ADDENDUM NO. 3

Warren Central High School Phase 3 Renovation and Addition 9500 E. 16th Street Indianapolis, IN 46229

This Addendum forms a part of and modifies the Bidding Requirements, Contract Forms, Contract Conditions, the Specifications and the Drawings dated January 3, 2023, by CSO Architects. Acknowledge receipt of the Addendum in the space provided on the Bid Form. Failure to do so may subject the Bidder to disqualification.

DRAWING NUMBER A903

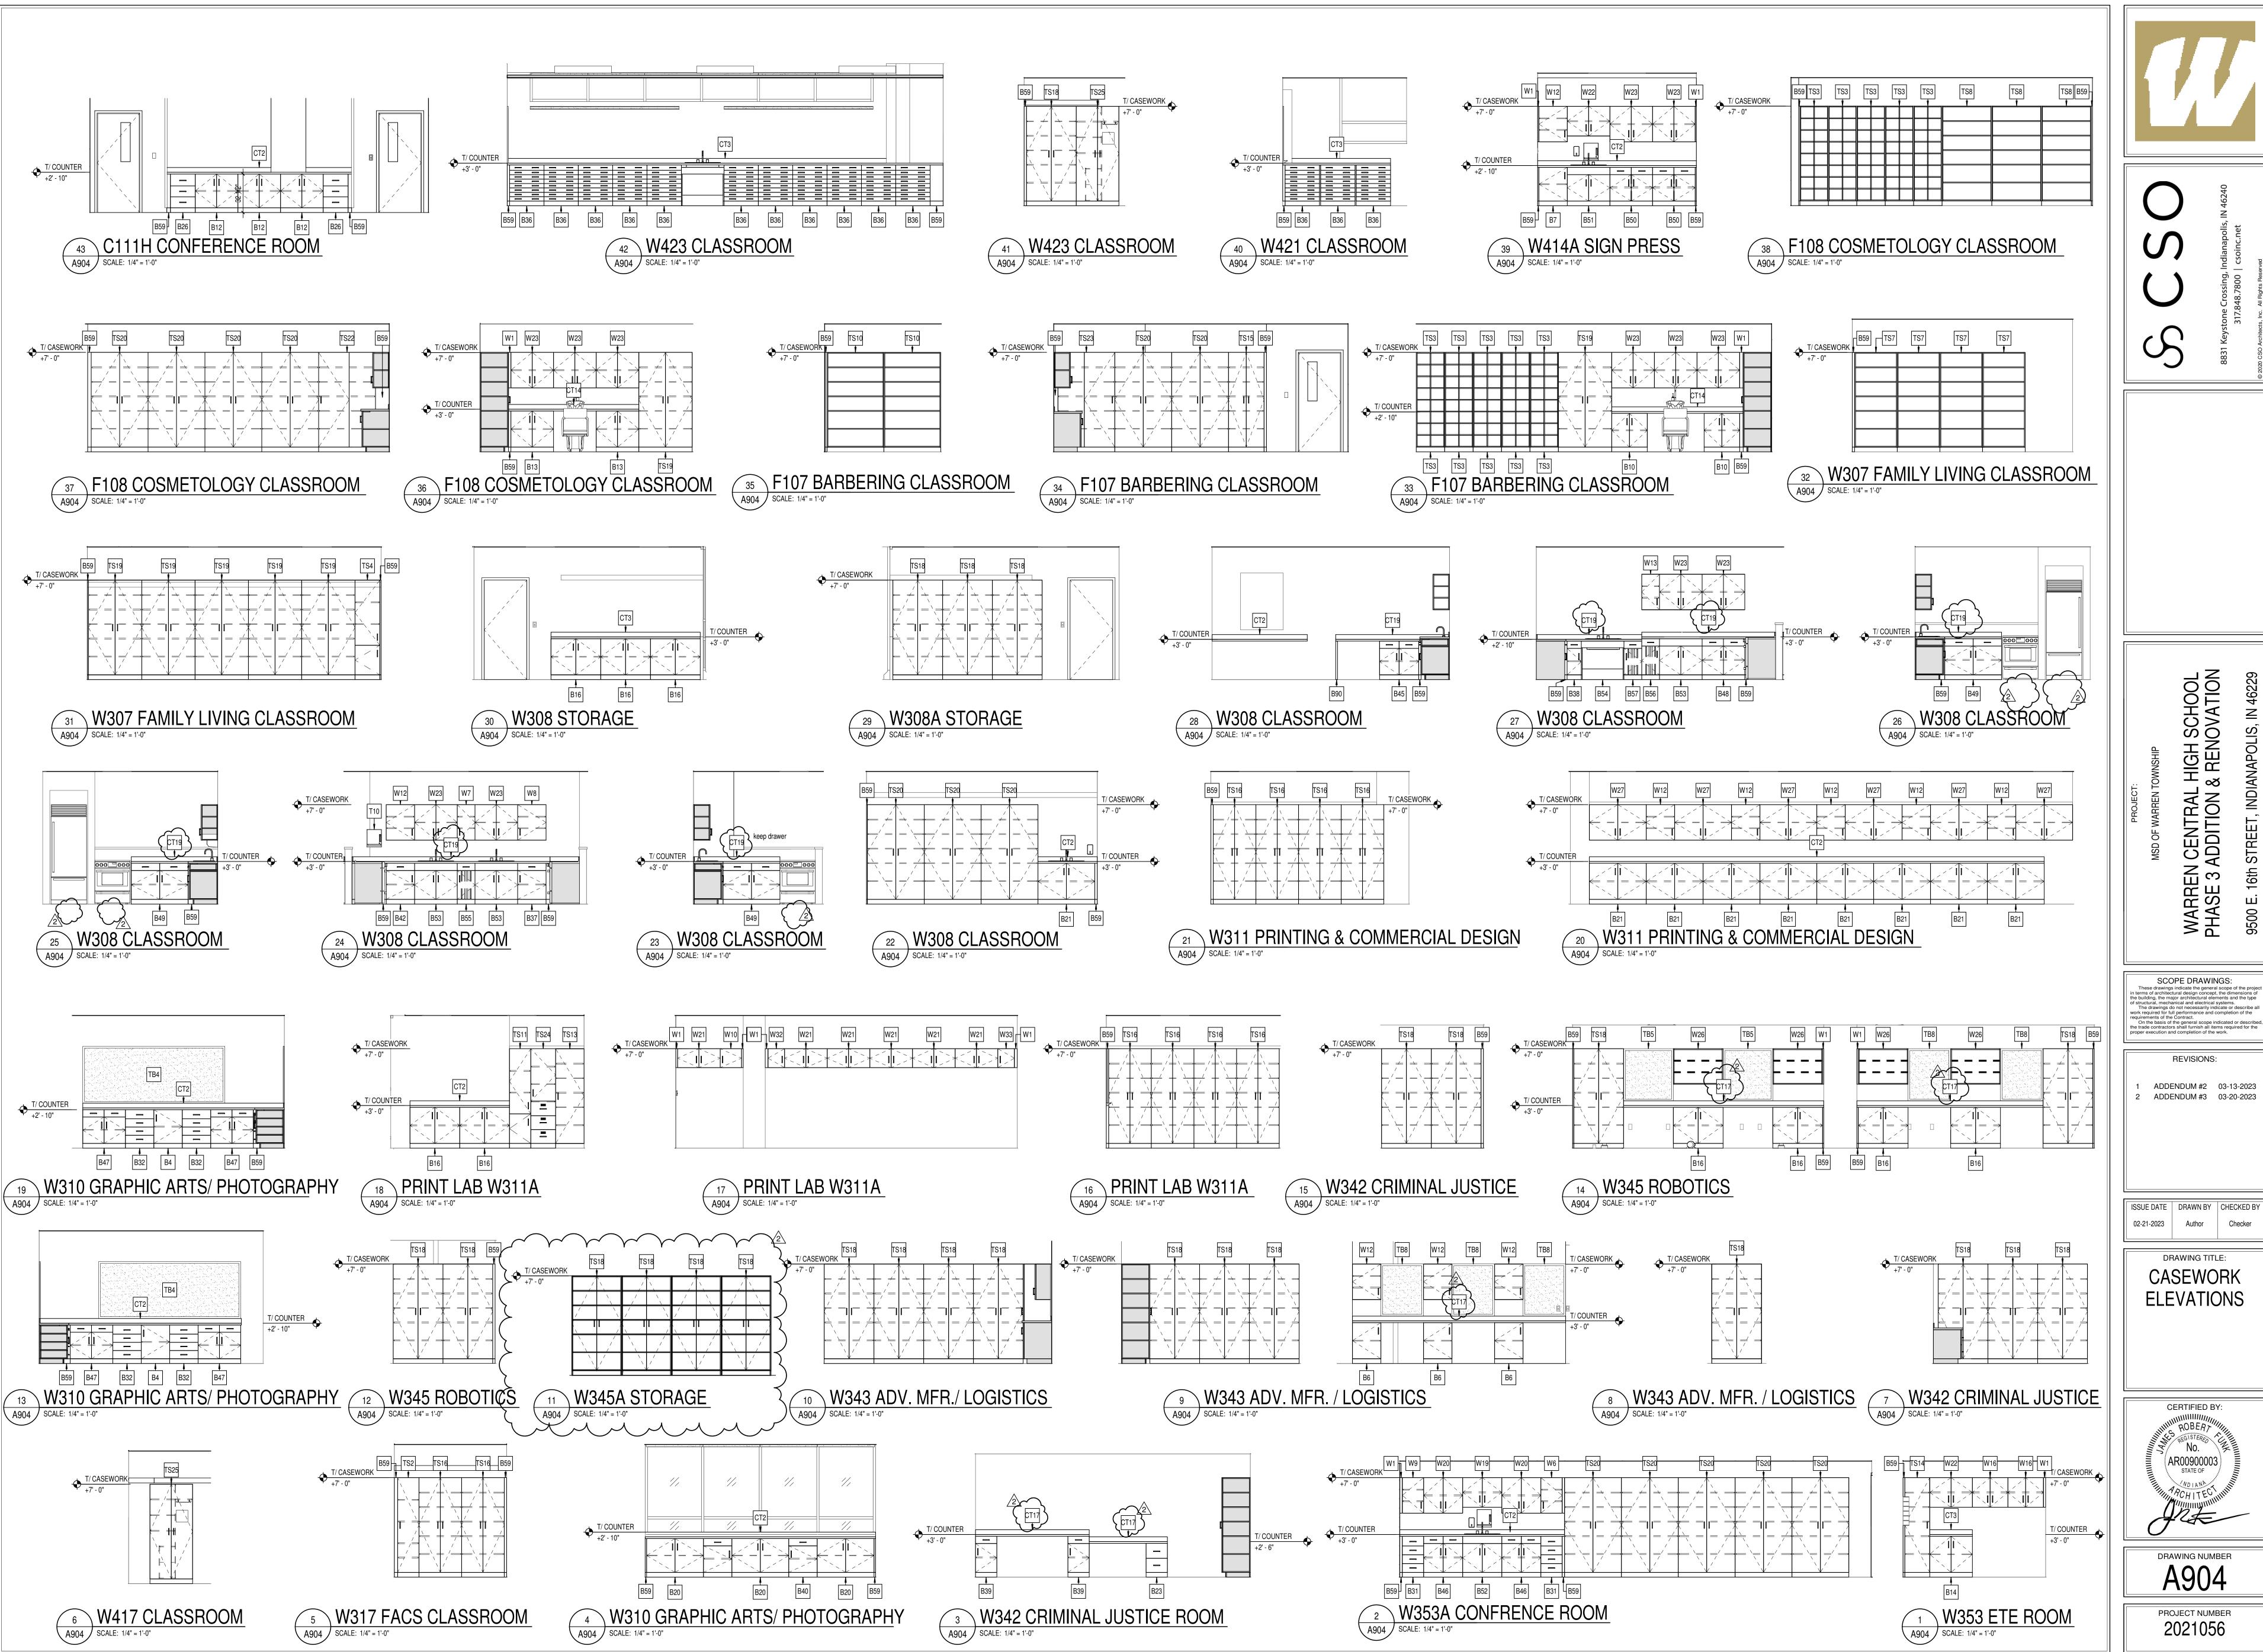
A. Update room numbers/elevation titles as indicated on attached, re-issued Sheet A903.
